ADDENDUM NO. 3

Project: CITY OF GREAT FALLS INDOOR AQUATICS AND RECREATION CENTER
Project No.: 20-019
Date: OCTOBER 6, 2021
Bid Date: OCTOBER 13, 2021

DESIGNED BY:	MB
CHECKED BY:	TMP
DATE:	08/19/21
PROJECT NUMBER:	20-019
SHEET NUMBER:	A10.3

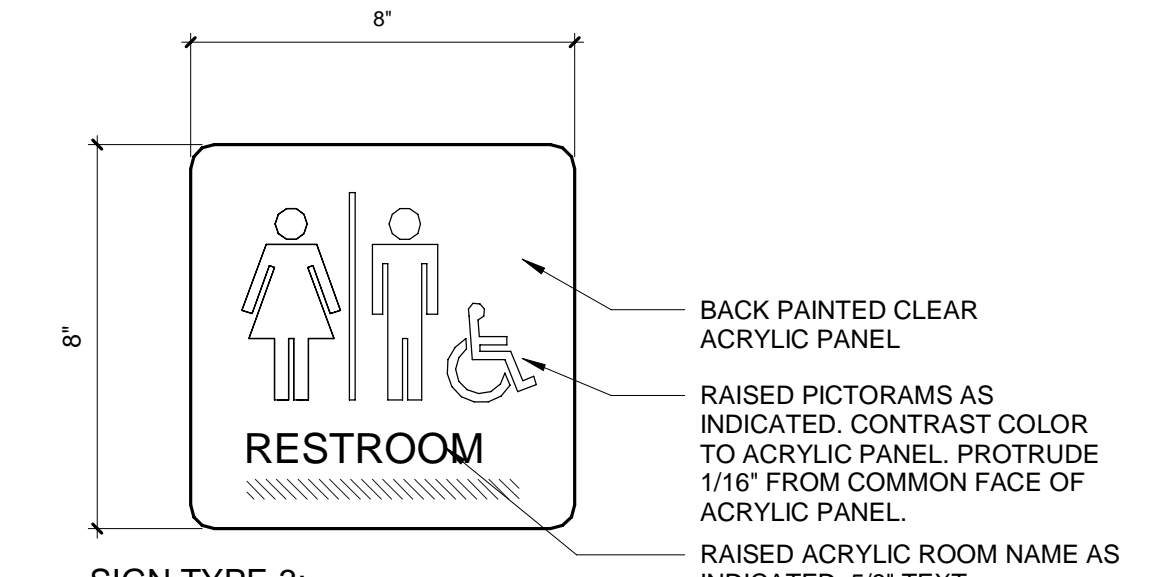
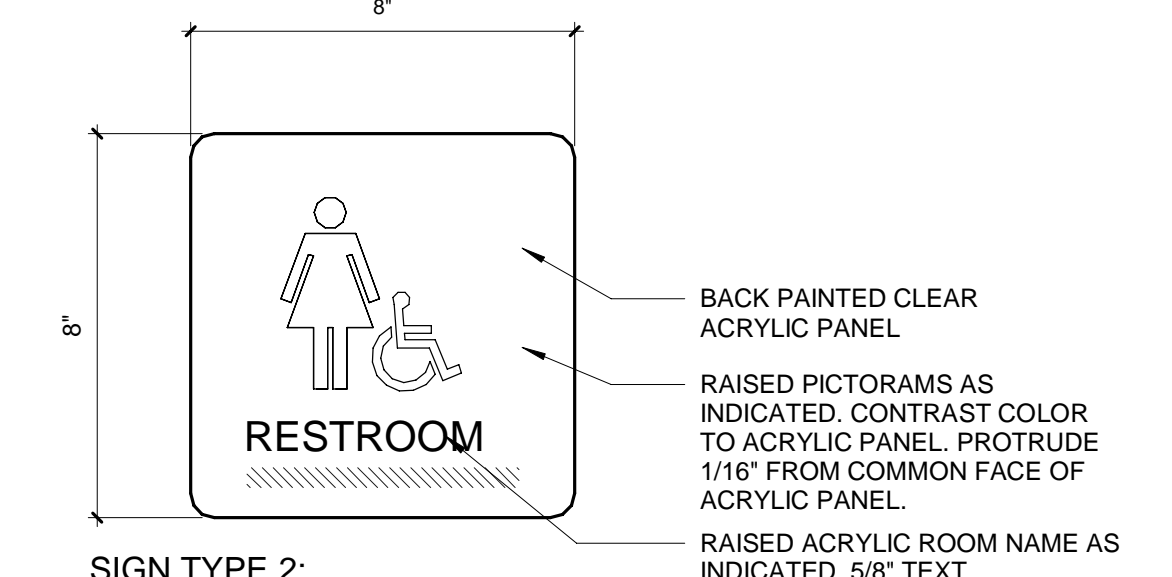
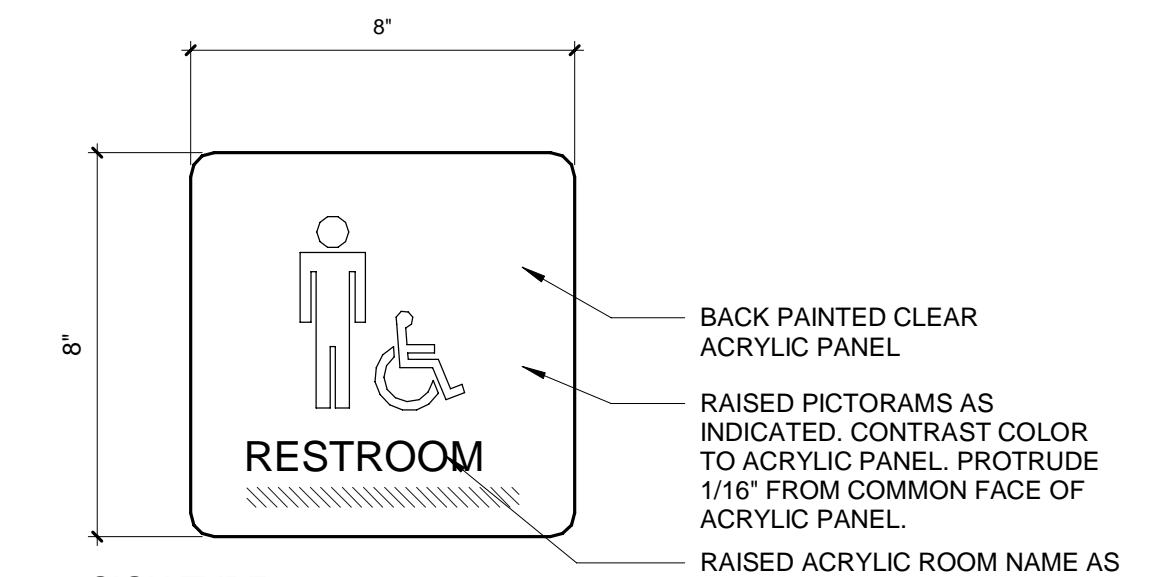
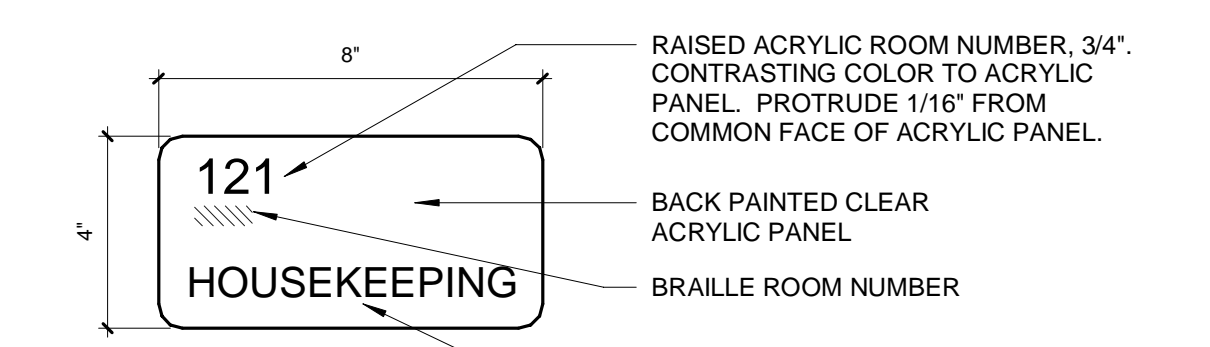
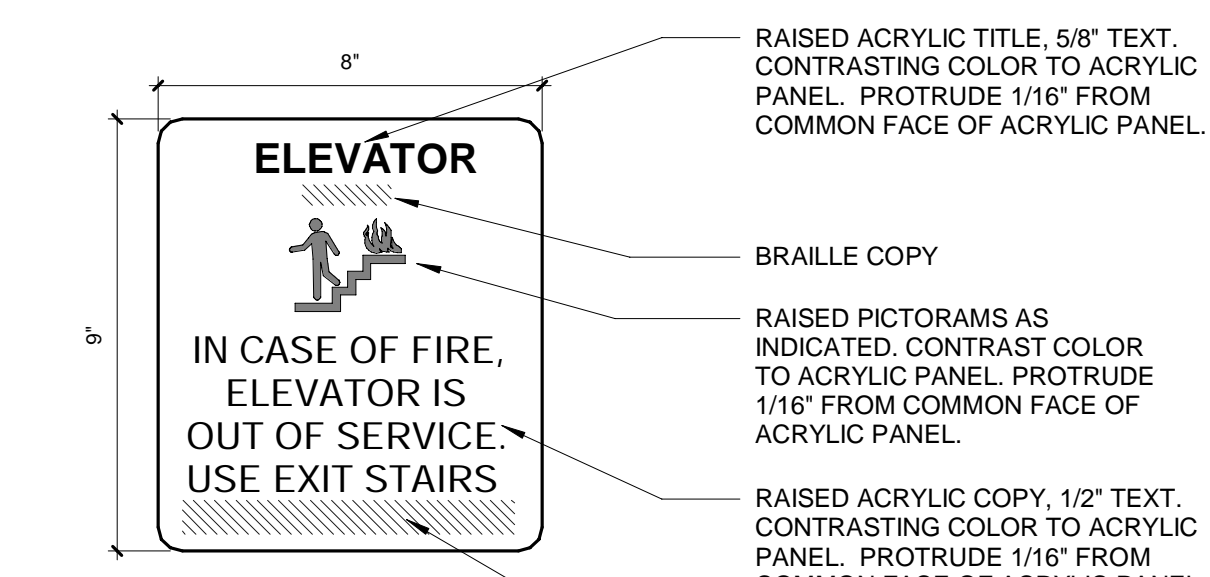
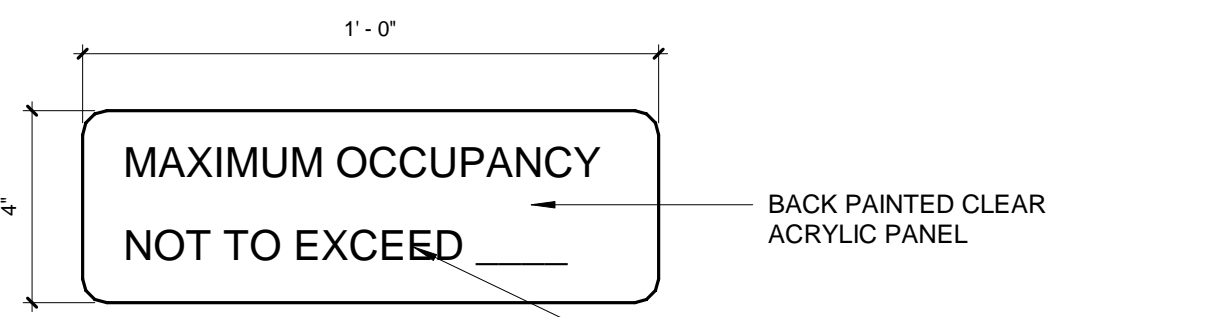
ITEM NO. 12. Sheet A10.3 **ADD:** Interior Signage Schedule. See Attachment "C".
